## ADDENDUM NUMBER ONE (1)

**DATE:** October 9, 2012

**RE:** BID NO. 2013-05 – Shoot House facility Building

**OWNER:** CITY OF EDINBURG

SHEET NO.  
 A4.0

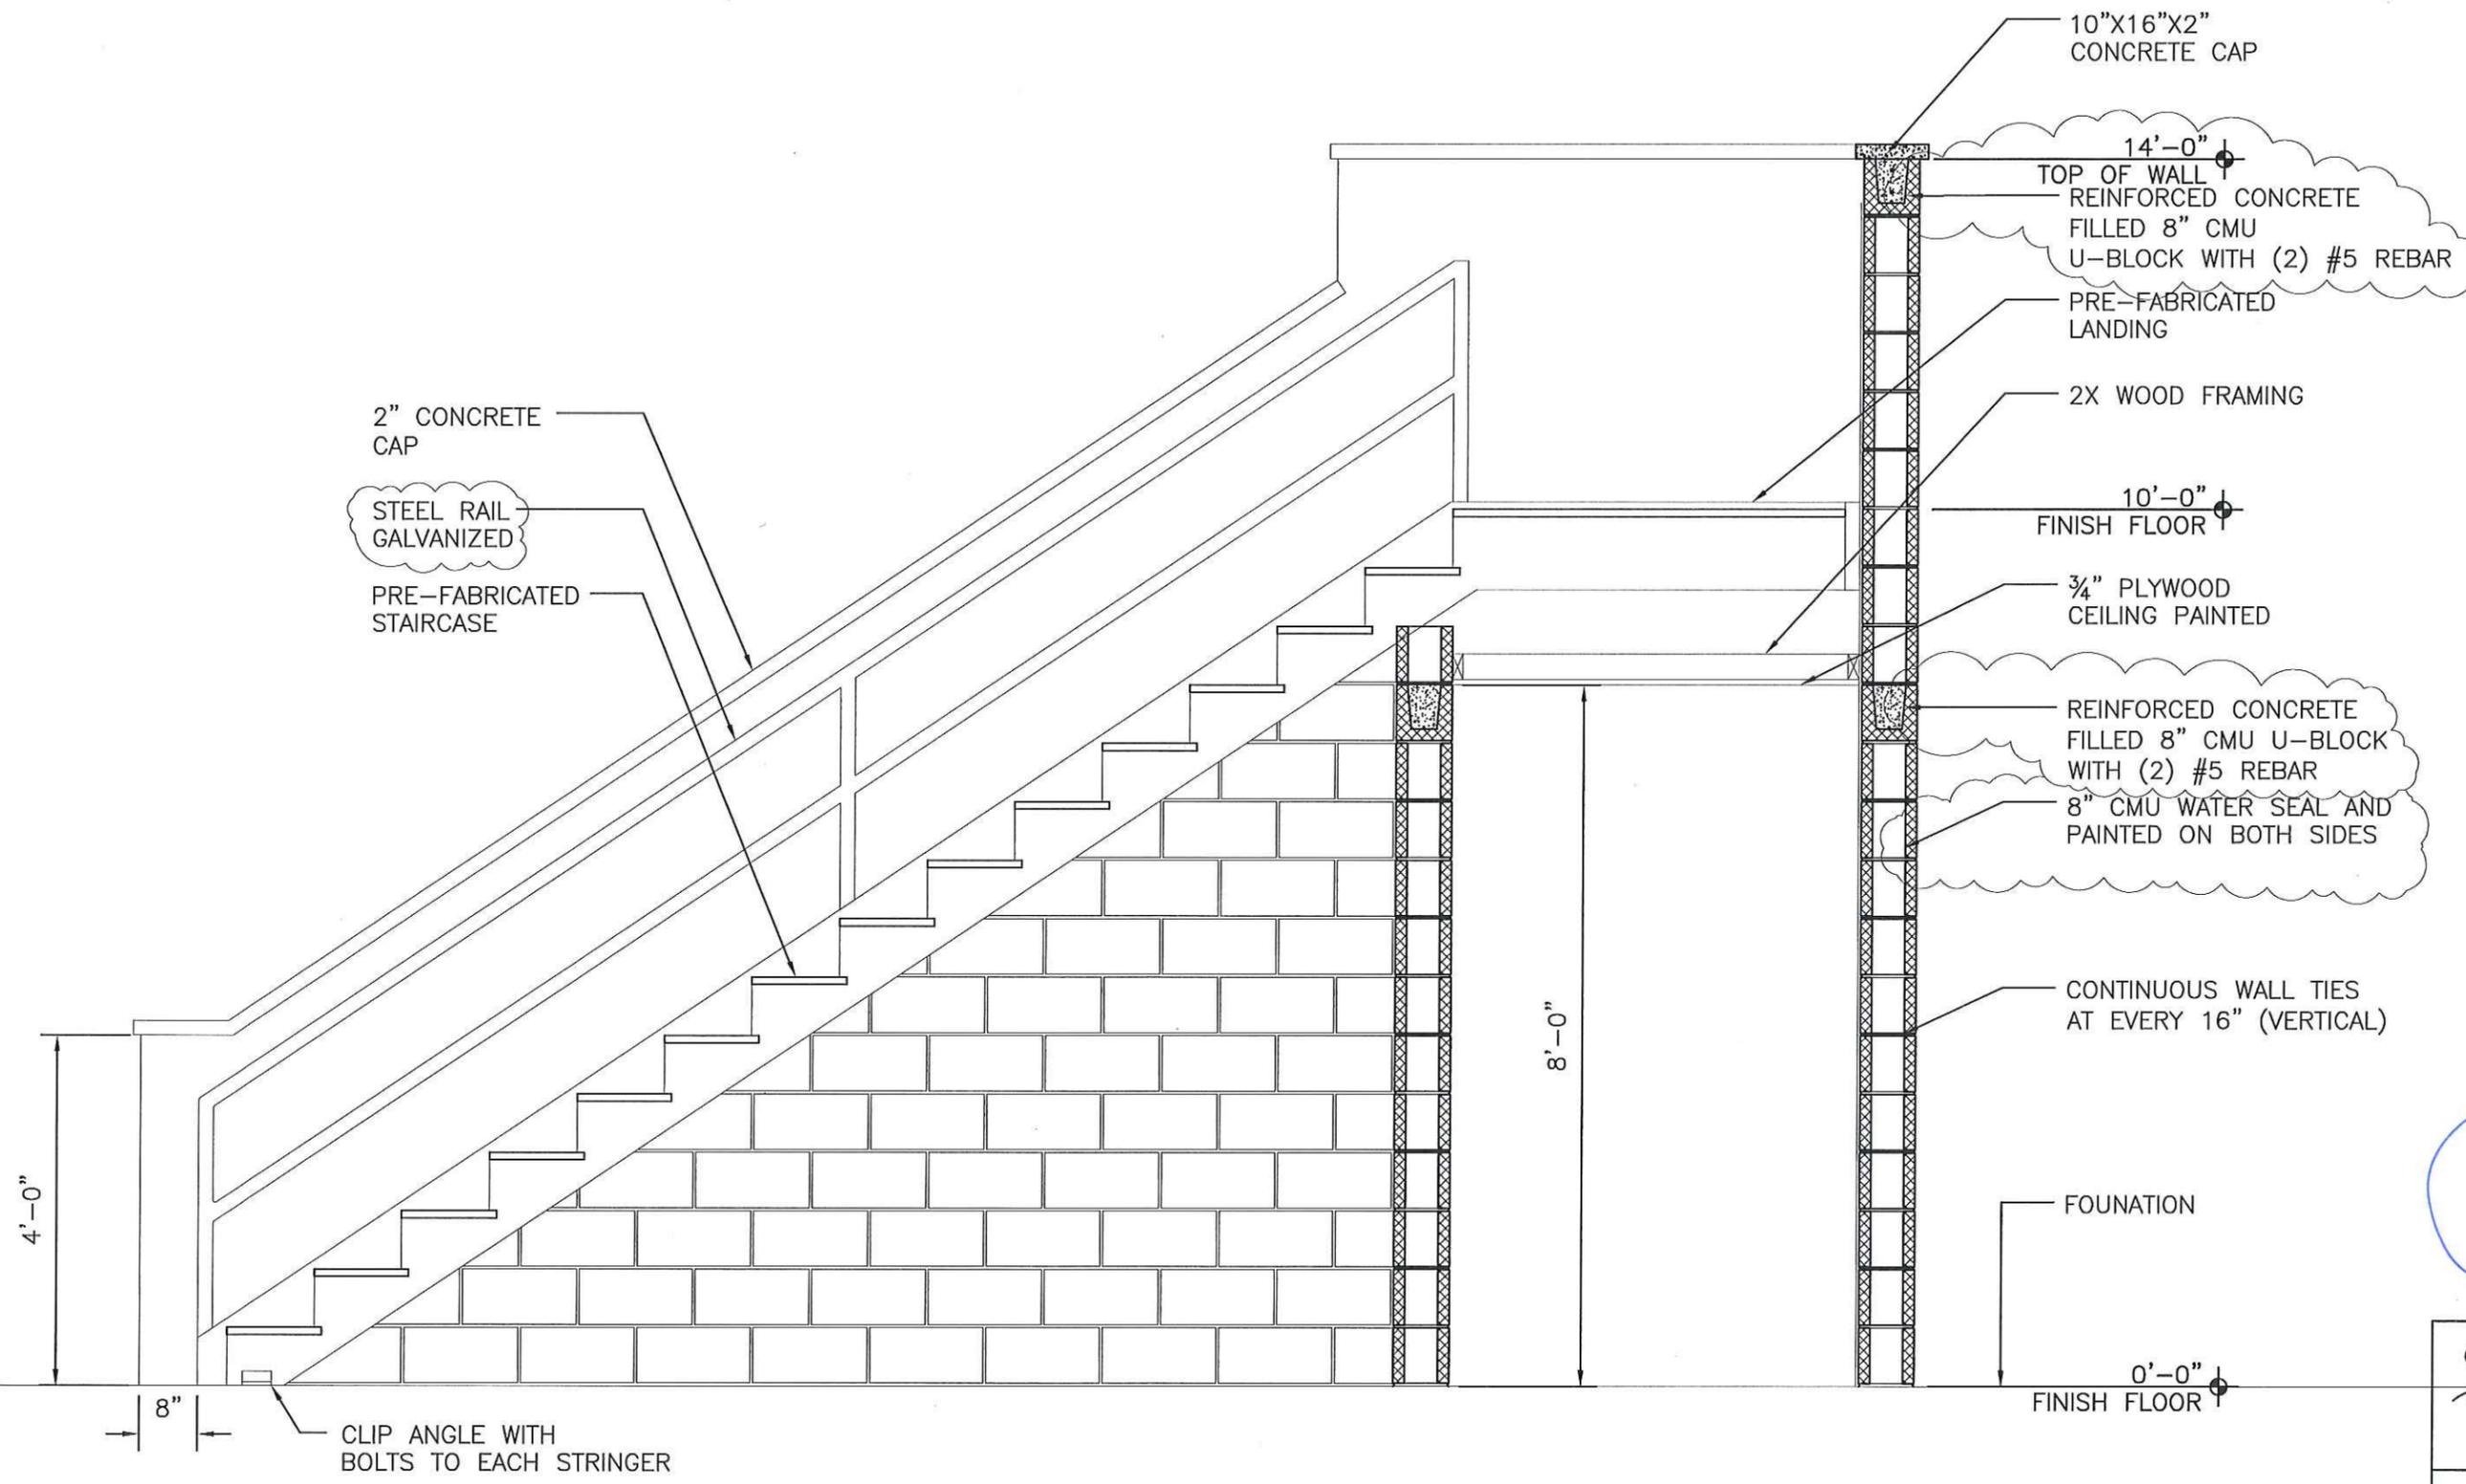
1. Revised Sheet 12 of 22 A4.0, and Sheet 14 of 22 A4.1 - **1. Detail 1 & 2** updating exhibits, removing Stucco Finish on Both Side and replacing with water seal and paint.

6. Revised Sheet 18 & 19 of 22 **Foundation Notes #4** – updating notes adding use #4 24" X 24".
7. Revised Sheet 12 & 13 of 22 **Wall Section Details 1 & 2** – Adding weep post to each wall section.

8. Revised Sheet 12, 13, & 14 of 22 **Wall Section Details 1 & 2** – Adding reinforcement bars #5.
9. Revised Sheet 12, 13, & 15 of 22 **Wall Section Details 1,1, & 2** – Removing expanded metal flooring and replacing with Steel bar grate flooring light duty galvanized.

10. Revised Sheet 12, 13, & 14 of 22 **Wall Section Details 1 & 2** – Adding Truss ladder at 16" on center (o.c.).
11. Revised Sheet 14 of 22 **Wall Section Detail 1** – Removing steel rail painted to be replaced by Steel Rail Galvanized.

1. Sheet 12 of 22 A4.0, **1. Detail 1 & 2 – CMU Wall** – CMU Block American or approved equal.
2. Sheet 14 of 22 A4.1 **1. Detail 1 – Stair Case** – Stair Case Pre-Fabricated or approved equal (If fabricated on site shop drawings are required.)

8. All Sheet 12 of 22 A4.01 **Detail** – Rail only on one side, exterior side away from the building.
9. Sheet 12, 13, & 15 **Details** – Contractor to submit shop drawing by steel company signed and sealed by a Professional Engineers (P.E.) on the gauge of steel for the catwalk, due to the fact that the gauge will vary due to the length of the span.

<b>THE CITY OF EDINBURG</b> Department of Public Works		
POLICE DEPT. SHOOT HOUSE		
SCALE	SHEET 14 OF 22	
VERT.	PROJECT NAME	FILE NAME
HORIZ.	SHOOT HOUSE	---
	DEPARTMENT	MONTH
	ENGINEERING	AUG.
		YEAR
		2012

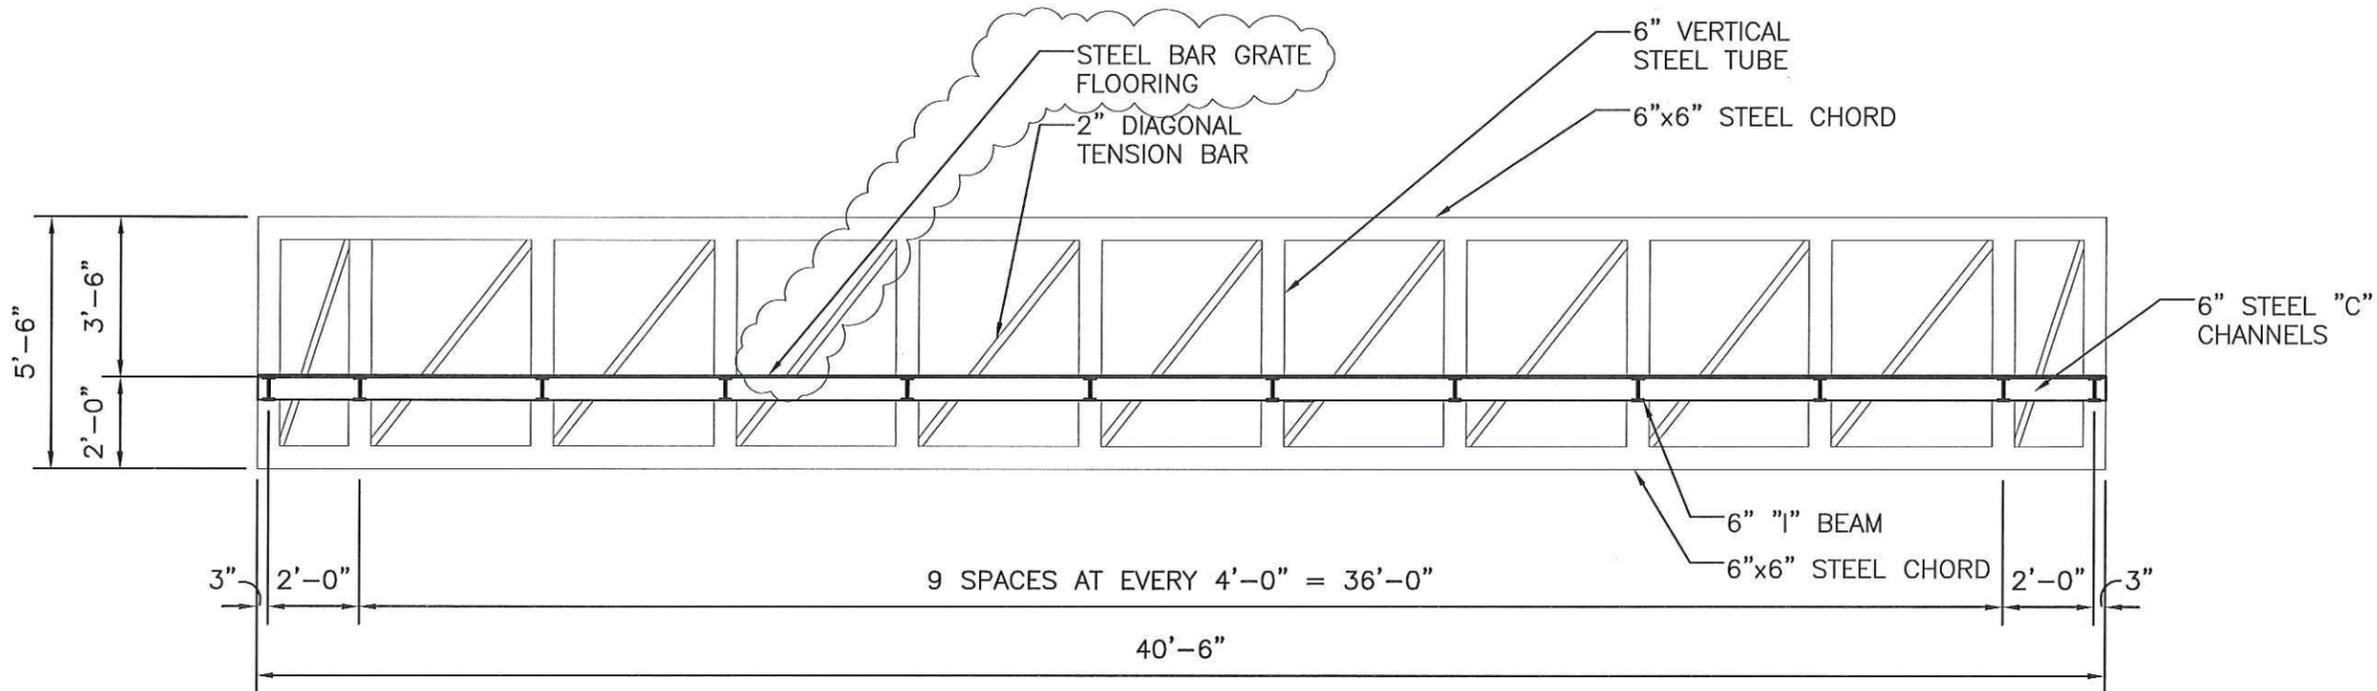
10. Sheet 14 of 22 Wall Section **Detail 1** – Tread risers will be closed on the Base Bid and the Tread risers will be open on the Alternate Bid.

1
**FOUNDATION PLAN**  
 SCALE: 1/8" = 1'-0"

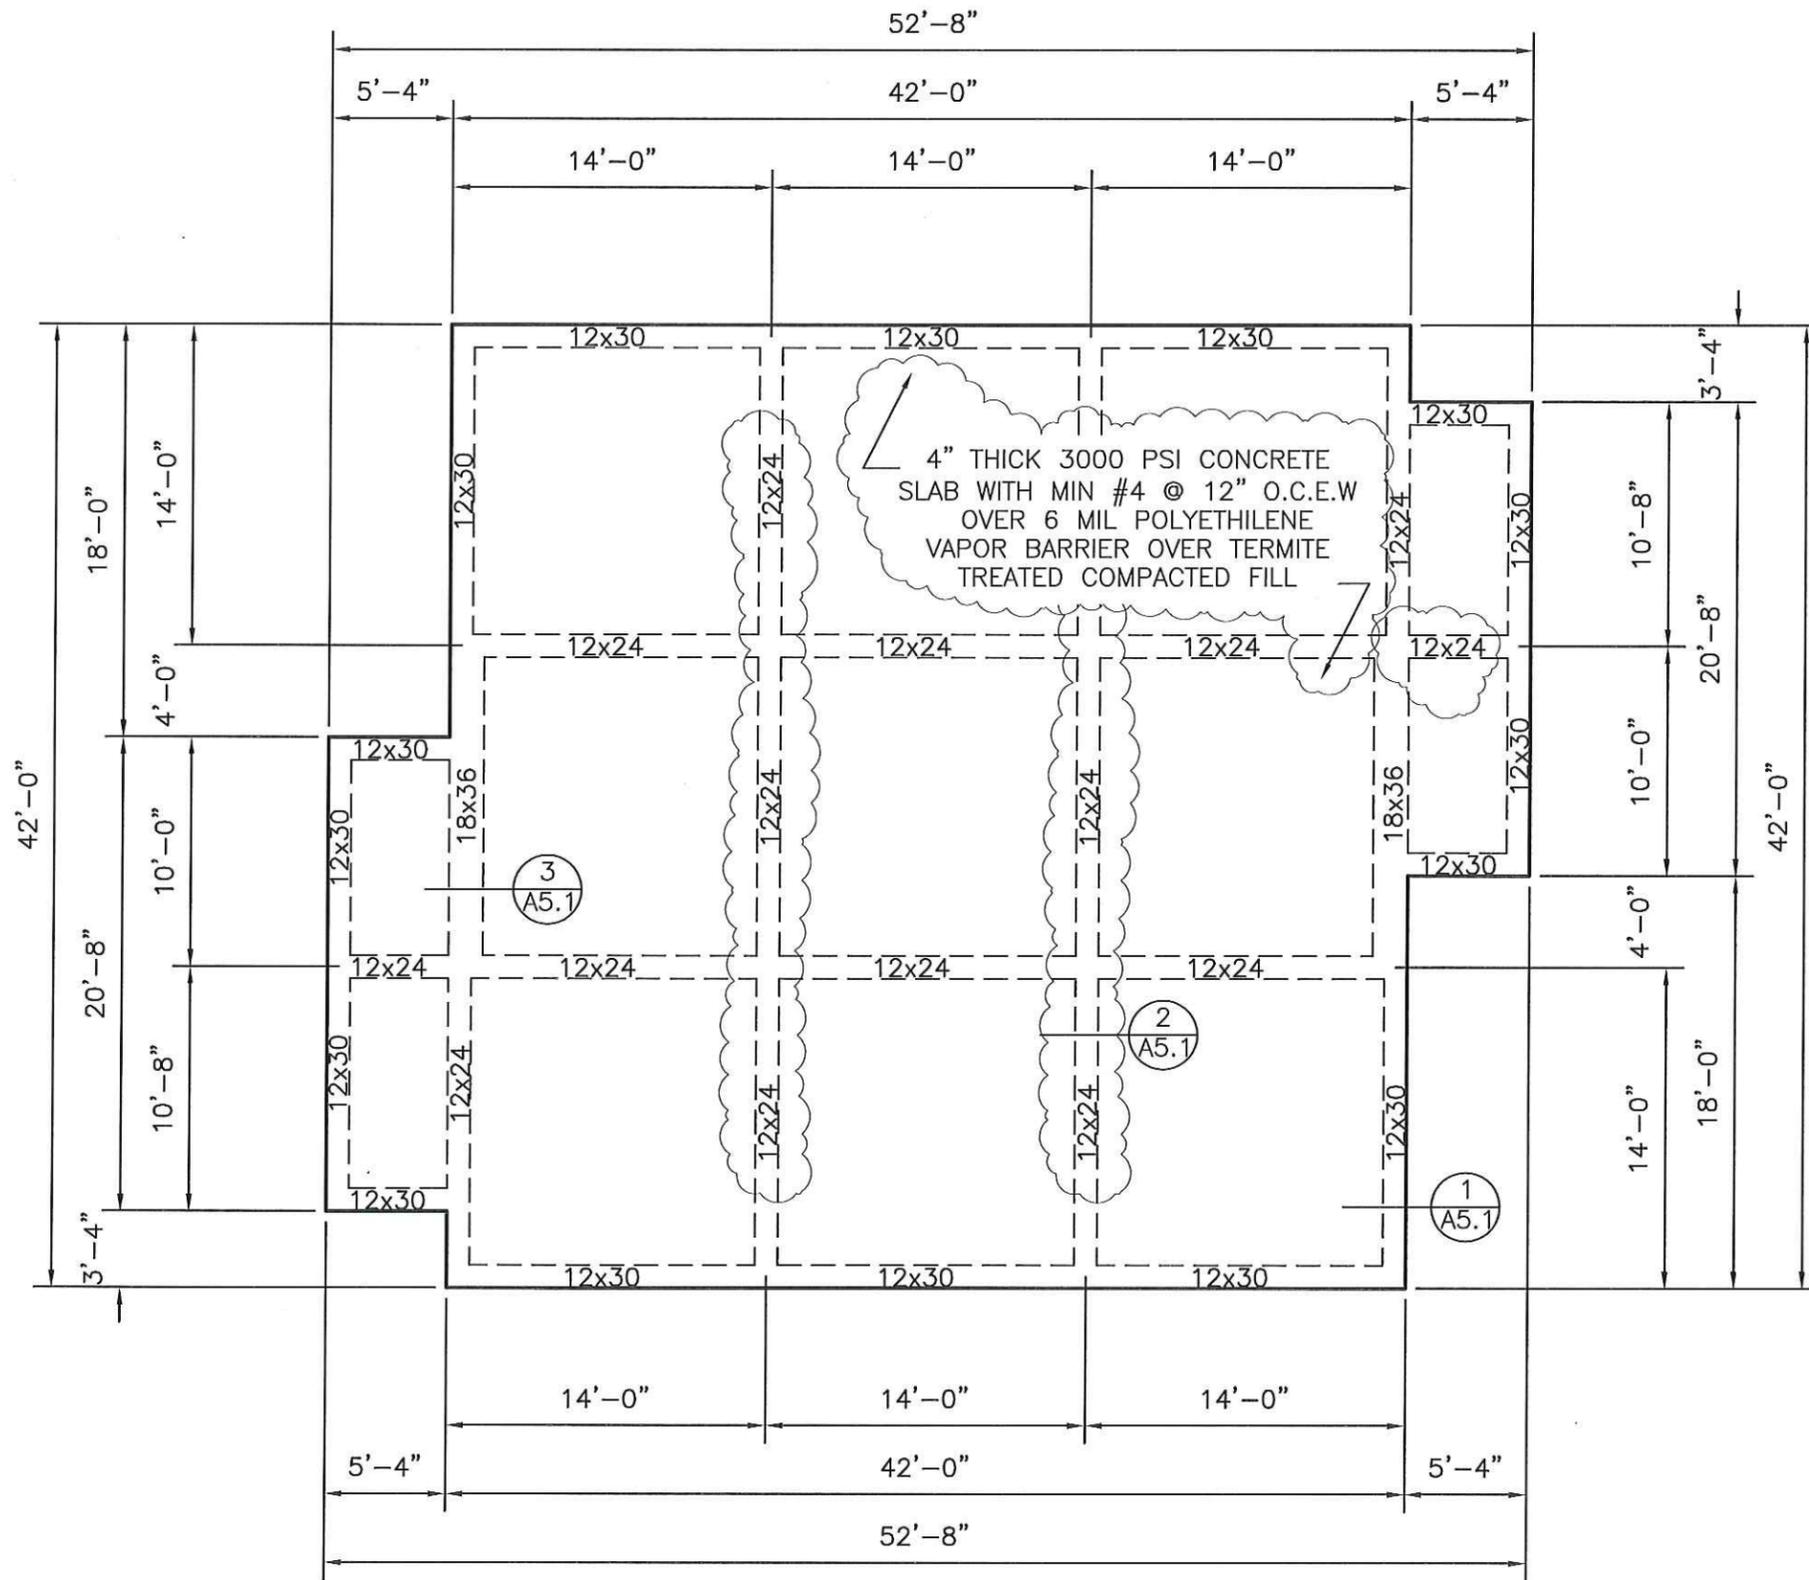
3. Revised Sheet 18 of 22 A5.1 **Foundation Details 1,2, & 3** – updating exhibits, removing #3 Rebar and Replacing with #4 Rebar.
4. Revised Sheet 16 of 22 A5.0 **Foundation Plan Detail 1** – updating exhibit, removing 12X30 interior beams and replacing 12X24 interior beams.

5. Revised Sheets 16 & 17 of 22 A5.05 **Foundation Plan Detail 1** – updating exhibit note, removing #6 gauge wire mesh and replacing #4 at 12" On Center Each Way (O.C.E.W.).

PROJECT NAME	FILE NAME	SHEET NO.
SHOOT HOUSE	--	A5.1
DEPARTMENT	MONTH	YEAR
ENGINEERING	AUG.	2012

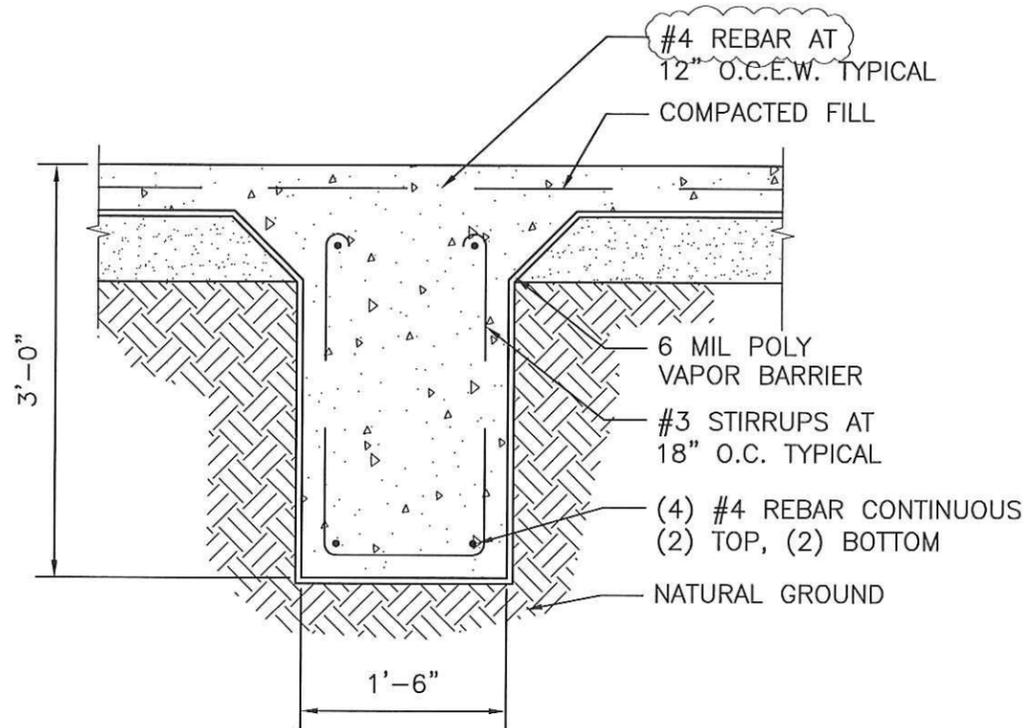
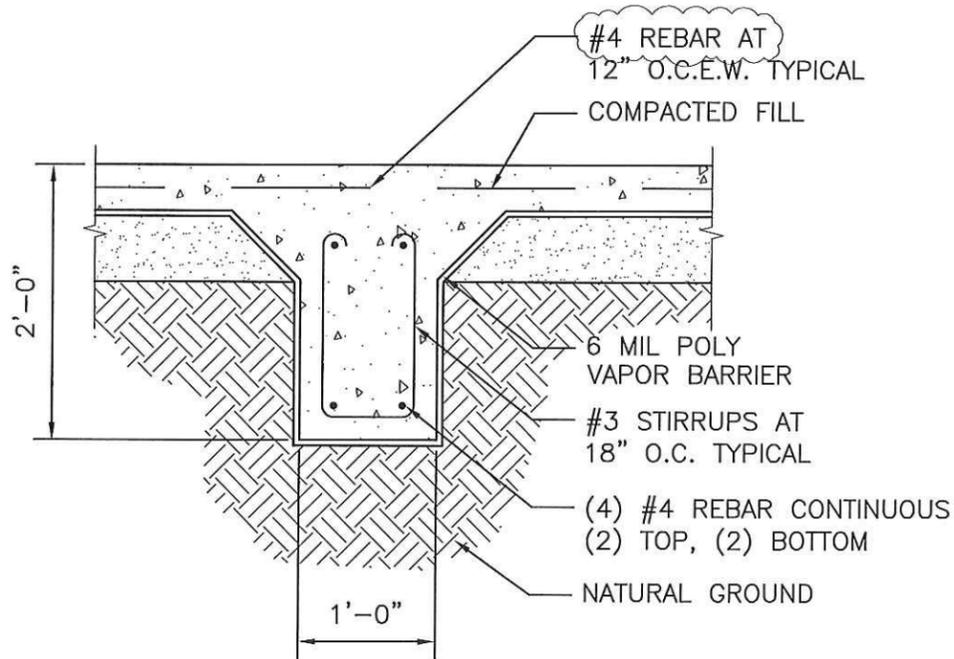
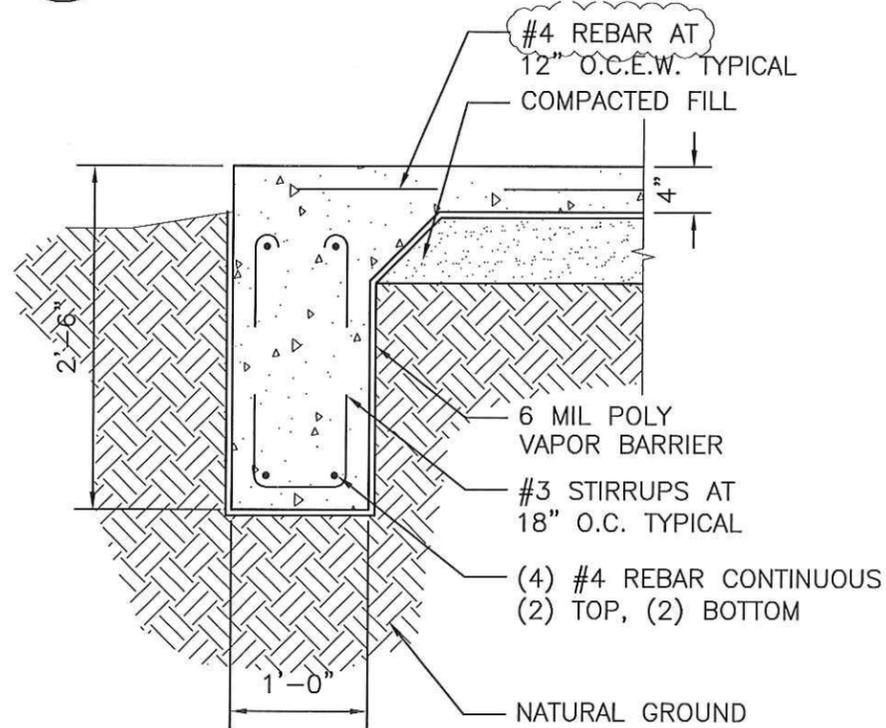
2. Revised Sheet 18 of 22 A5.1 and Sheet 19 of 22 A5.1 **ALT Foundation Note #3** – Updating note, removing 4½" Thick Slab and replacing with 4" Thick Slab and removing #3 rebar and replacing with #4 rebar.
